5046 Valle Del Sol Rd. NW RE:

Grading and Drainage Plan Engineer's Stamp Date: 09/07/18

Hydrology File: J11D038

Based upon the information provided in your submittal received 09/10/2018, the Grading Plan is **not** approved for Building Permit. The following comments need to be addressed for approval of the above referenced project:

MCDONALD - GRADING & DRAINAGE PLAN

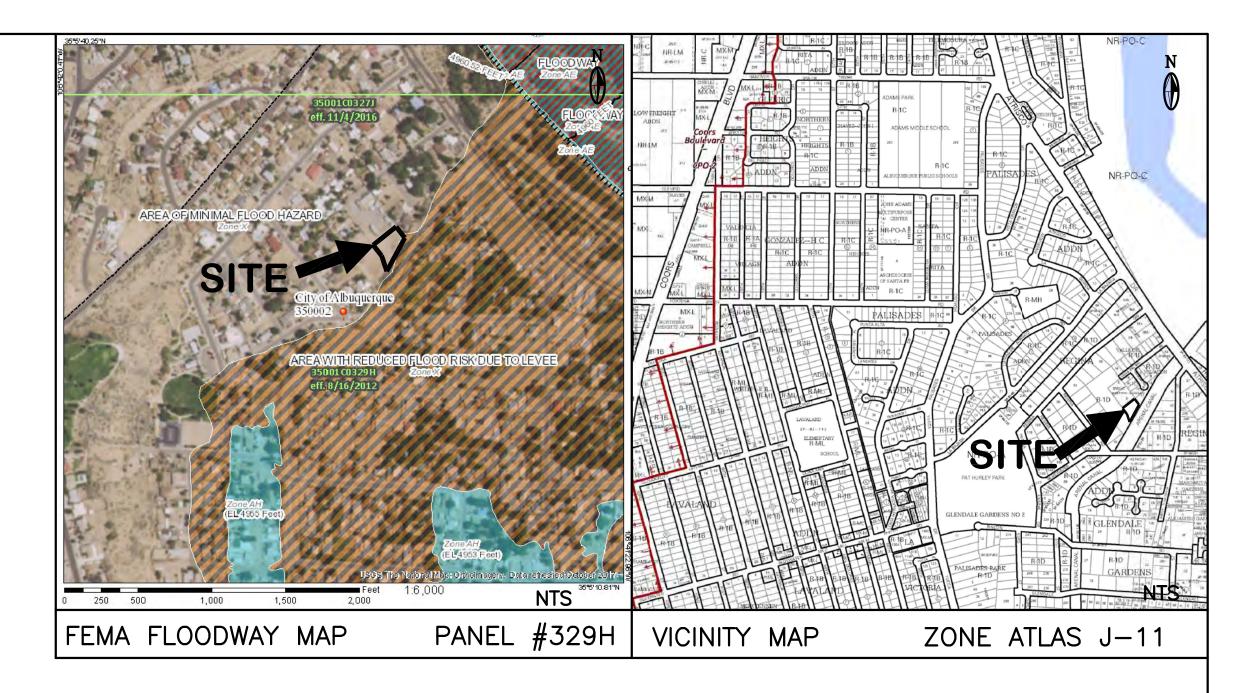
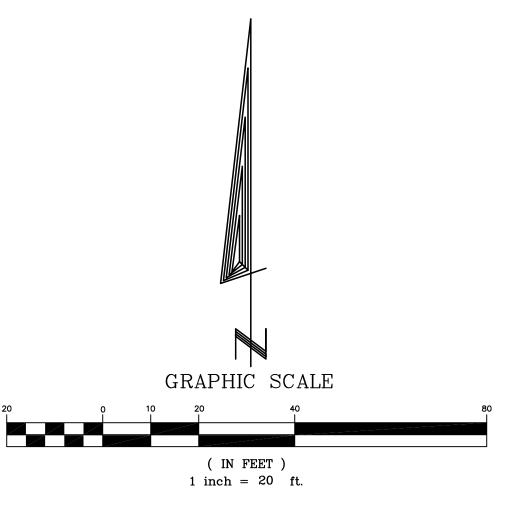
- 1. Currently the design does not follow the Flat Grading Scheme outlined in the DPM. Please follow Chapter 22 Section 5.G (Flat Grading Scheme). The following conditions must be applied to the site:

- a. The maximum percent impervious of the lot and the contributing area may not be greater than 45%.
 - b. Pad elevation shall be a minimum of one (1) foot above the 100 year 10-day storm water surface elevation.

- c. The flow between the front yard and back yard cannot be obstructed. The storm water must be allowed to equalize to the same level between the front yard and back yard.

- d. A permanent perimeter wall or barrier around the development is required to contain the 100 year 24 hour storm developed runoff.
 - e. The high point of the street should be four inches above the 100 year 10-day storm water surface elevation.

- 2. Also a retention pond is required. The required volume = (3.67 in. X impervious area / (12in/ft)). The location with elevation of pond and the calculation of both the required and actual volume needs to be shown on the Grading Plan.

3. Please place gravel and slope the hammer head on this project's property at least. Transportation may want the entire hammer head built. This is for the Fire Department. The area of this graveled hammer head needs to be included in the Type C soil in the calculations.
